# Technical Service Bulletin

## 19 Coolant warning light or coolant loss - R8 4.2 FSI

19 13 38 2026109/3 May 14, 2013. Supersedes Technical Service Bulletin Group 19 number 13-37 dated May 13, 2013 for reasons listed below.

Figure 1. Splash guard aligned with fan control unit.

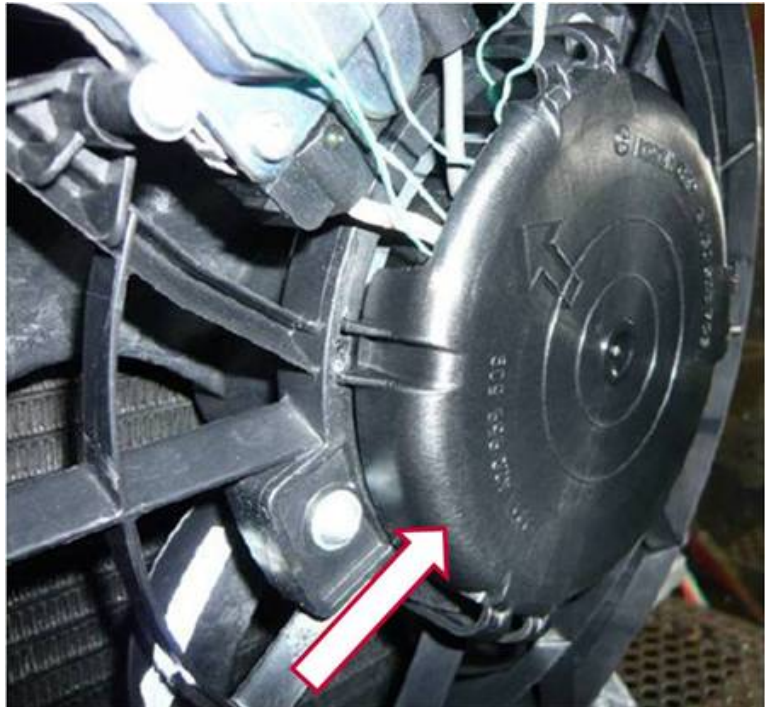
A splash guard was installed on the cooling fan to protect the fan motor and the fan control unit (Figure 1).

**Tip:** The splash guard must be fitted with the arrow on the splash guard aligned with fan control unit.
